20/0935/MRES| Land At Pinn Court Farm Pinn Court Lane Exeter EX1 3TG

10th July 2020

Exeter Cycling Campaign objects to the proposed Pinn Court Farm Phase 2B development on grounds that the proposed cycling measures fall short of what is required in this area. If delivered as written, this development will bake in a high level of private car use with resultant impacts on congestion, air quality and Exeter and East Devon's Net-Zero plans.

Figure 1 Proposed route of the Langaton Lane Link cycle route (green dotted line alongside M5 motorway)

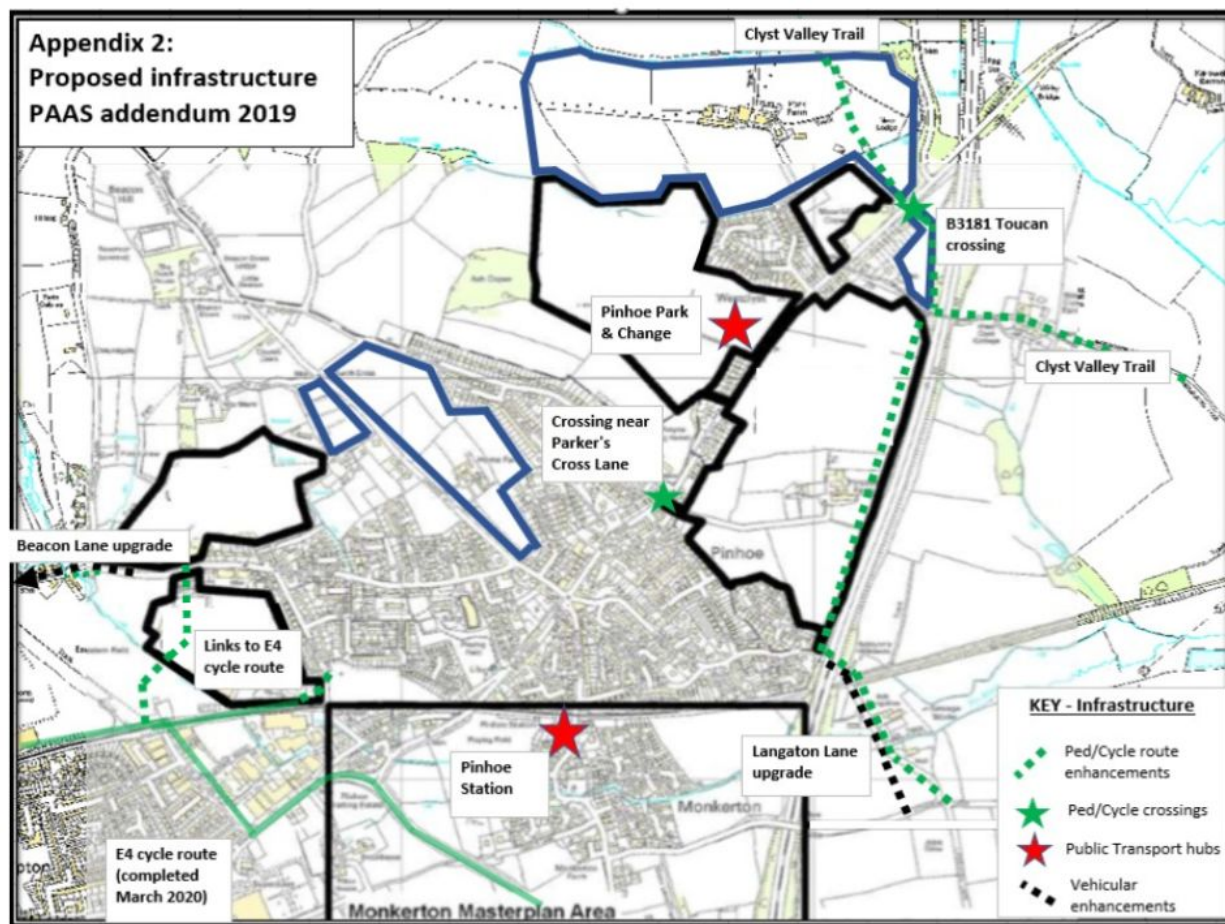
Crucially, Exeter Cycling Campaign notes that the Langaton Lane Link (LLL) has still not been delivered. This is a key mitigation in the Pinhoe Area Access Strategy (Figure 1) and currently the only mitigation for the Pinhoe area since the Exhibition Way Link was cancelled. This makes the LLL all the more pressing to be delivered as soon as possible, and certainly before the residential increases in Pinhoe and Westclyst are continued.

The PAAS Addendum 2019 notes that there remains a funding gap for the LLL. The cycling and walking portion of the LLL must be constructed as a priority for ensuring the sustainability of the development and to ensure that private car use is not baked into this development. Thus, this proposal must be subject to a funding contribution to the LLL and a Grampian condition to complete the LLL prior to occupation of the residences.

- 1) It is crucial that funding must be included for the Langaton Lane Link with a Grampian Condition to complete the cycle way of the LLL prior to completion and/or occupation of the residences.

Figure 3: Approximate gradient of proposed Parkers Cross Road route showing at least 7% gradient in both directions

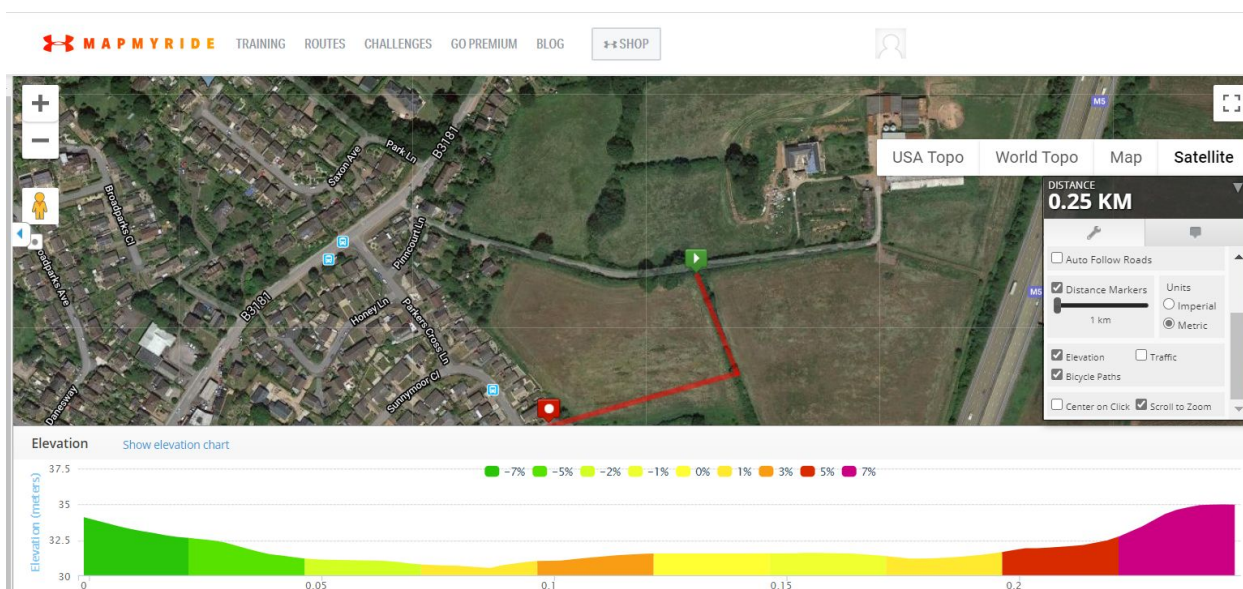
Exeter Cycling Campaign welcomes this addition. However, the plans note that there is especially steep terrain in the South West of the proposed site. The proposed Parkers Cross Lane route contains gradients in excess of 7% (Figure 3) (with the potential to reach 10% depending on the exact routing). This far exceeds best practice of ensuring gradients are less than 5%. Excess gradients disproportionately discriminate against users with disabilities, women (especially parents) and older people. For this route to be suitable for cycling it must be developed to ensure that it is accessible for all users which means designing to minimise gradients.

- 3) The Parkers Cross Road route design must meet best practice standards including a minimum width of 3m and minimising gradients to under 5% wherever possible.

Figure 4: Major access road design from the Design and Access statement

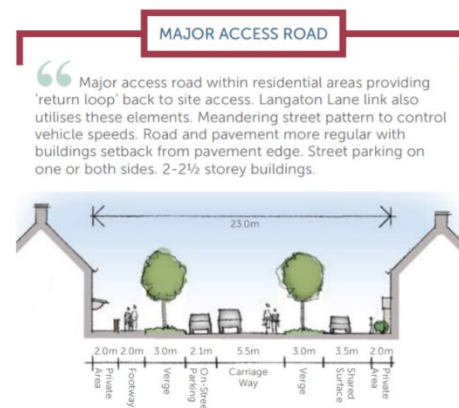
Regarding road design, the diagram of what the main access road design means shows a car on the shared surface with bicycle users on the carriageway (Figure 4). Exeter Cycling Campaign is therefore duly concerned as to what the intended use of the shared surface is and concerned that it may also include parking, particularly as it states “Street parking on one or both sides”

It is possible that this is a mistake/misunderstanding and if so, the inclusion of a 3m verge buffer from the carriageway is welcomed. If this is not a mistake however, then Exeter Cycling Campaign must object to this design. Street parking must be physically separated from any shared use path to ensure there is no possibility of conflict between vehicles and bicycle users and particularly that there is no inclusion of a dangerous “door zone” on the shared path (where parking is alongside a cycle path and as a result there is the danger of a bicycle user colliding with a car door when opened – Figure 5)

- 4) The major access road design should be modified to ensure there is no sharing between vehicles and bicycle users and there must be no generation of a dangerous “door zone” alongside the shared path.

Figure 6 shared surface access way design from the design and access statement

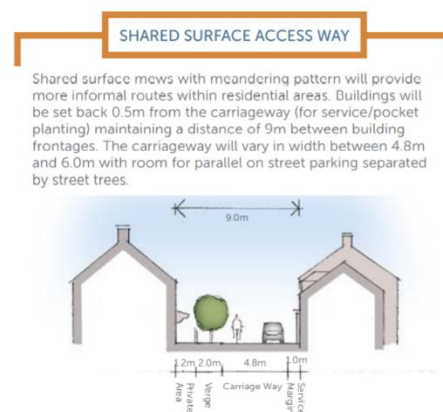
Exeter Cycling Campaign notes that where the major access road is not proposed, shared surface access ways are proposed for many of the properties (Figure 6). This design code appears to suggest there is no separate footway. Despite the proposition that “meandering streets will reduce speed” this is of great concern for the safety of pedestrians, particularly children,

Exeter Cycling Campaign asserts that inclusion of on street parking rather than a footway is against the principles of a “pedestrian first environment” and demonstrates that this proposal is inherently car centric and must be opposed and modified.

- 5) Shared surface access ways should be re-designed to include a footway, at the minimum on one side of the road, ideally on both.
- 6) Cycle parking at the shop should be clarified. Provision must be numerous enough and convenient enough ensure the private car is not the default method of transport. Cycle parking must be designed to accommodate non-standard cycles as well as standard cycles (e.g. trikes, recumbent, trailers) to ensure full accessibility and no discrimination.
